Docket Number:	08-AFC-03C
Project Title:	Marsh Landing Generating Station Compliance
TN #:	202671
Document Title:	Petition to Amend
Description:	N/A
Filer:	URS
Organization:	URS
Submitter Role:	Applicant Consultant
Submission Date:	7/8/2014 1:25:20 PM
Docketed Date:	7/8/2014

**PETITION TO AMEND
MARSH LANDING GENERATING
STATION
(08-AFC-3C)**

NRG Marsh Landing LLC

URS Corporation

FIGURE 1

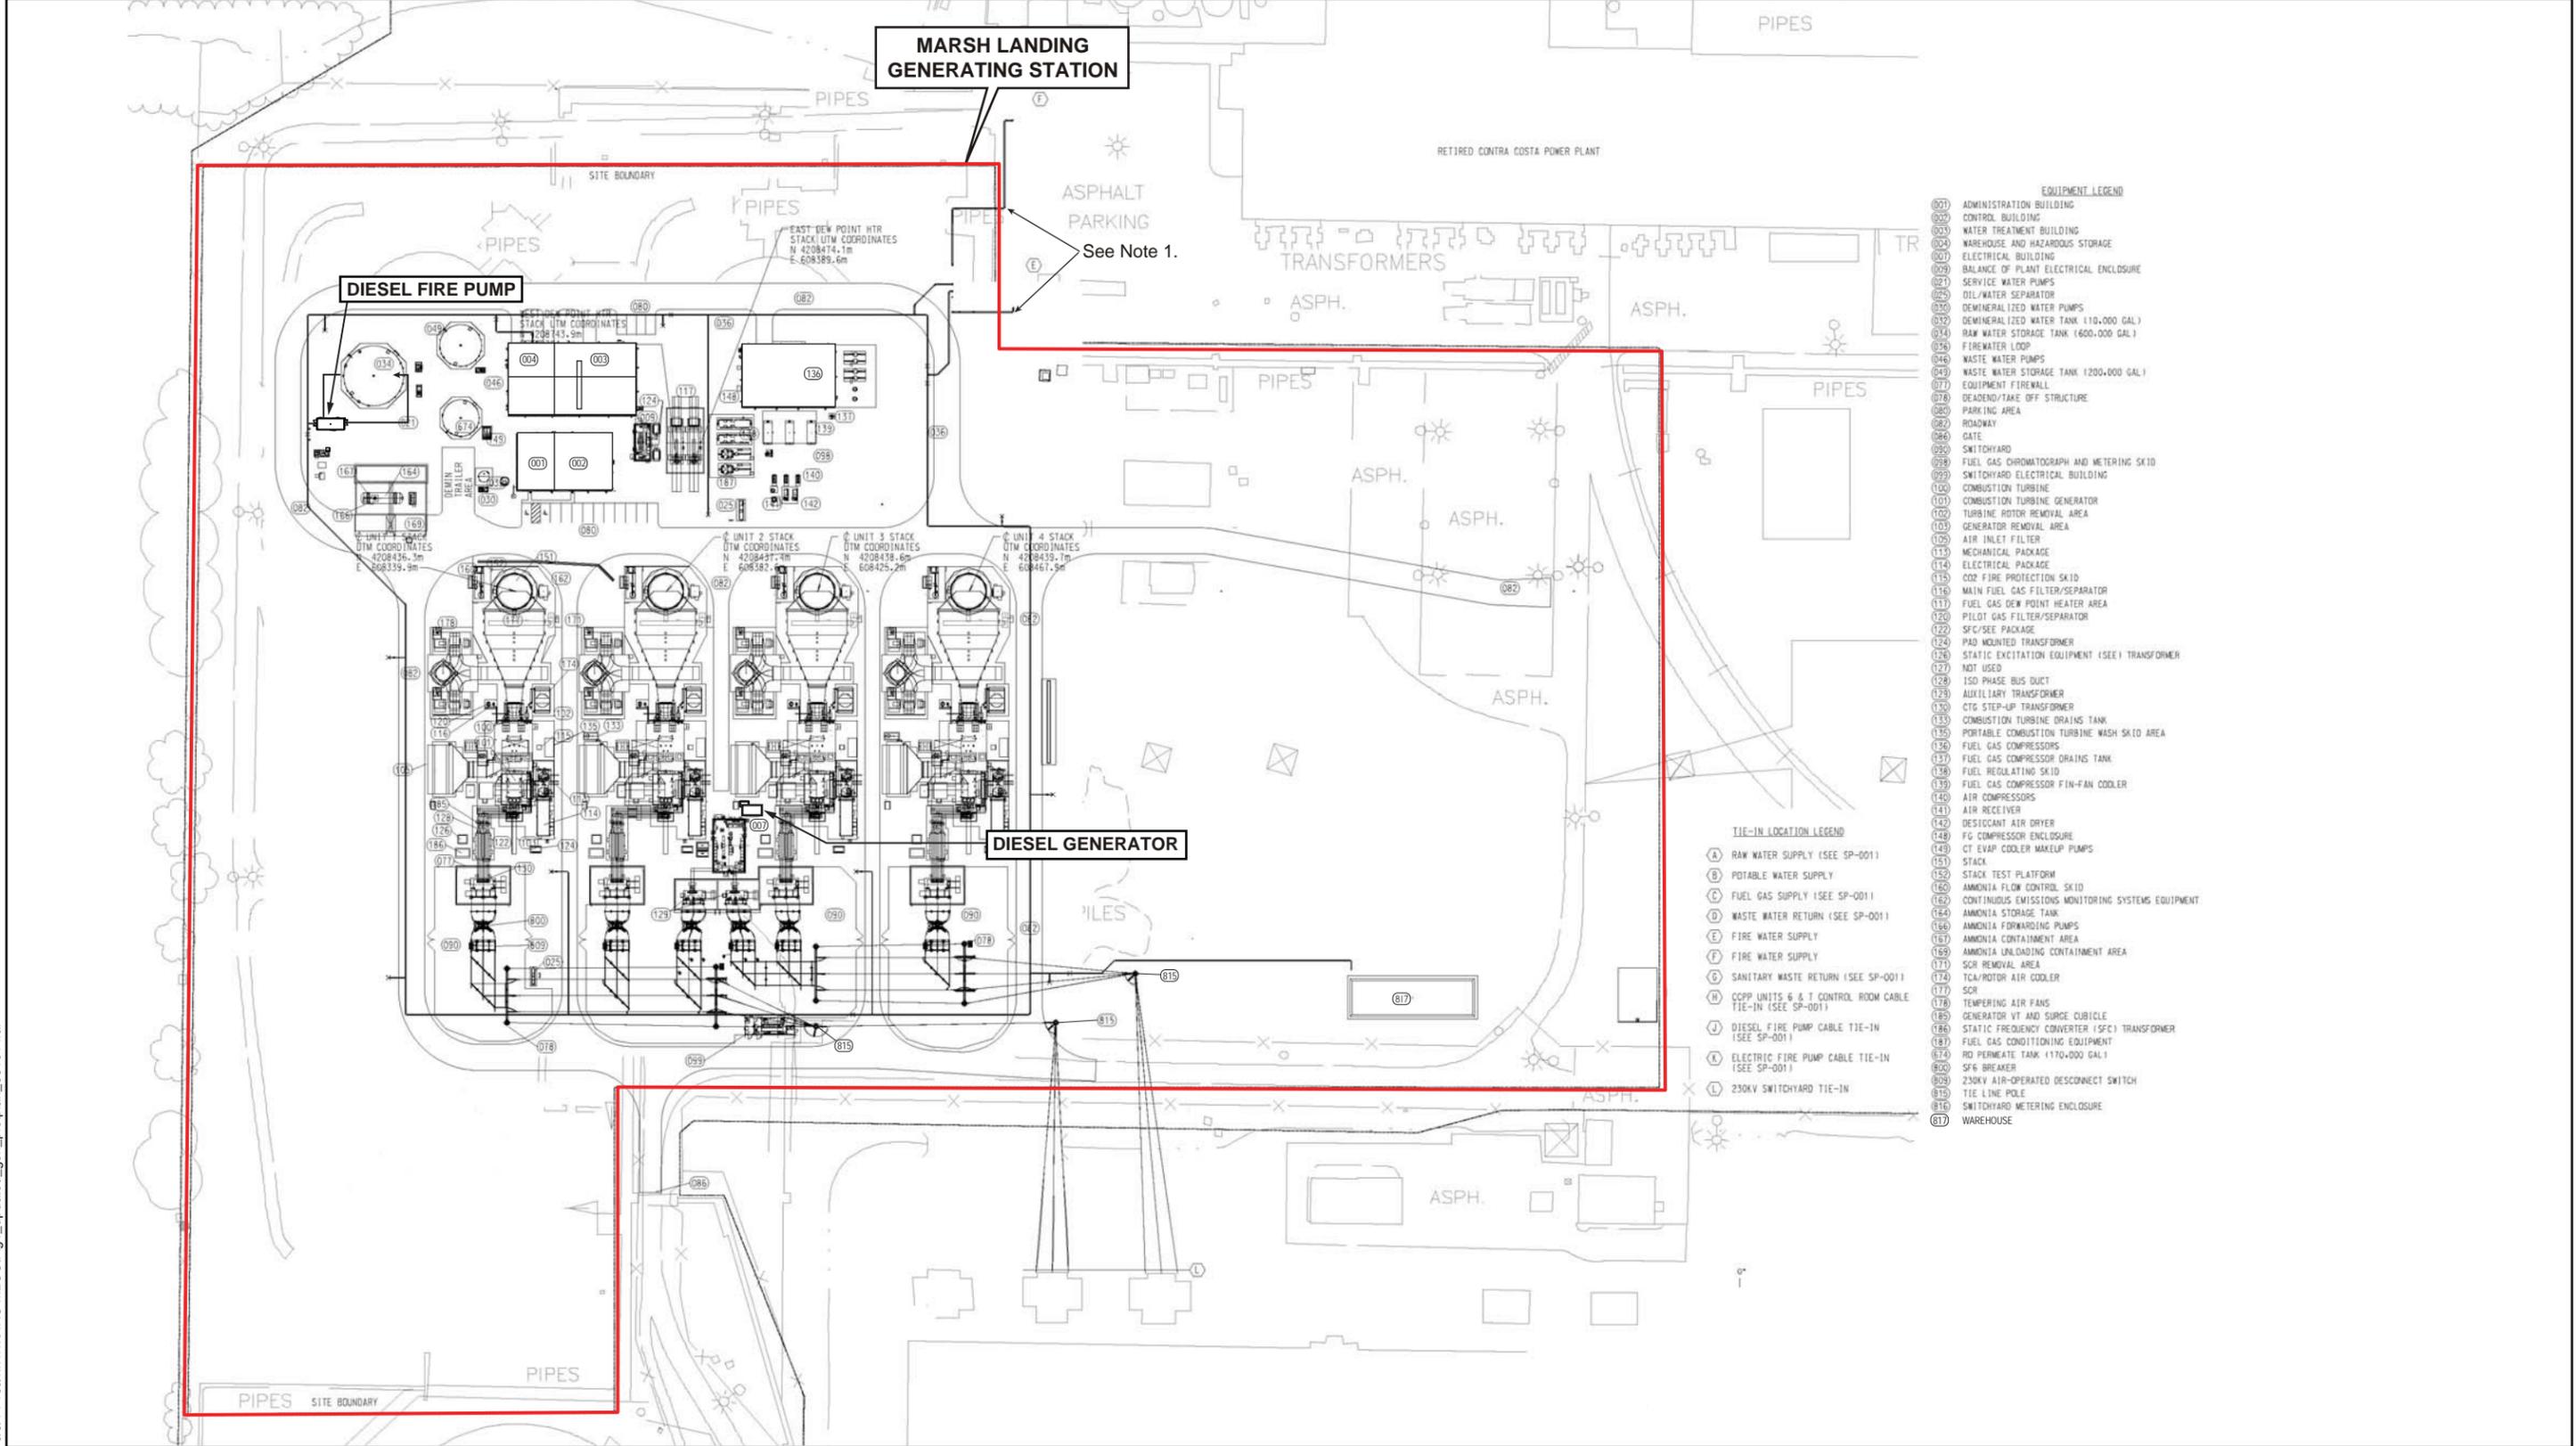
- The new emergency generator will be located between Units 2 and 3 as shown on Figure 1.
- The new emergency generator will be housed inside a small equipment cabinet that will be approximately 192 square feet in area and 12 feet tall. The equipment cabinet will be placed on a concrete foundation pad; maximum depth of excavation for the foundation is approximately 3 feet.

- The fire suppression system will be modified to include a new diesel fire pump and associated piping. The new diesel fire pump will be located near the Raw Water Storage Tank and the existing fire loop piping as shown on Figure 1. There will be a minimal amount of new connection pipe (i.e., approximately 150 lineal feet). Some of the piping will be underground and some will be above ground. Maximum depth of the underground piping will be approximately 5 feet below ground surface.

The new diesel engines will be located as shown on Figure 1. The new engines will each operate up to 50 hours per year for maintenance and testing. The project modifications do not alter the size, configuration, location or operation of the four simple cycle units consisting of four Siemens 5000 F natural gas-fired combustion turbine generators (CTGs) with ultra-low NO_x combustors and inlet air evaporative coolers.

The project modifications include addition of two diesel engines as shown on Figure 1. The emergency generator will be inside a small equipment cabinet approximately 12 feet tall and will be located between Units 2 and 3. The fire pump will be inside a small building approximately 14 feet tall and will be located near the Raw Water Storage Tank. These changes will be visually imperceptible when the project is viewed as a whole. This is because the largest features associated with the project (e.g., exhaust stacks and combustion turbine generators) will not be altered as a result of these refinements. Furthermore, neither the emergency generator or fire pump facilities would visually dominate the site, nor would they create a visual point of interest due to their size in relation to the other plant facilities. Therefore, these changes will not modify the existing analysis or conclusions presented in Section 7.11 of the AFC or the AFC Amendment. Therefore, potential visual impacts at all seven key observation points are expected to remain less than significant with implementation of the Conditions of Certification adopted in the Commission Decision.

Note:
 1. CCGS Fire System Pipes to be capped.
